Rahmat Sweaters (BD) Ltd. (Extension)

11-Sep-2023

1. **Sweater Building-2:** This structure is a six storied (B+G+5) reinforced concrete (RC) building with one basement.

Toilet block in drawing but production floor on-site.

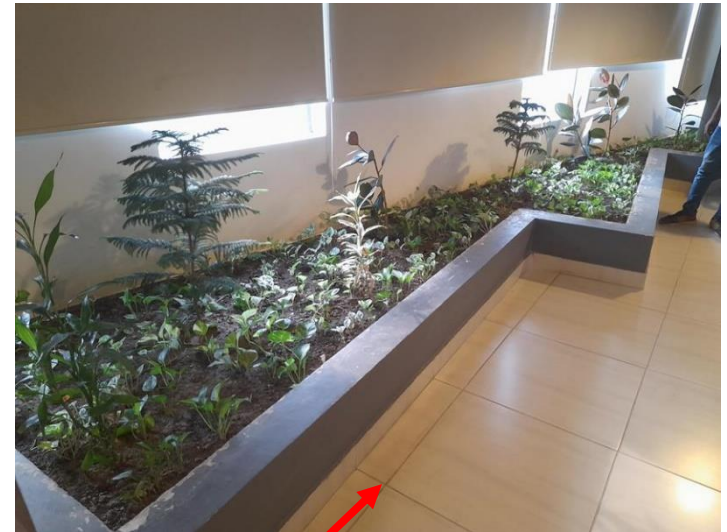
Toilet with build-up was found at cantilever portion as marked in layout plan.

Building engineer is required to survey the structures and update as-built drawings.
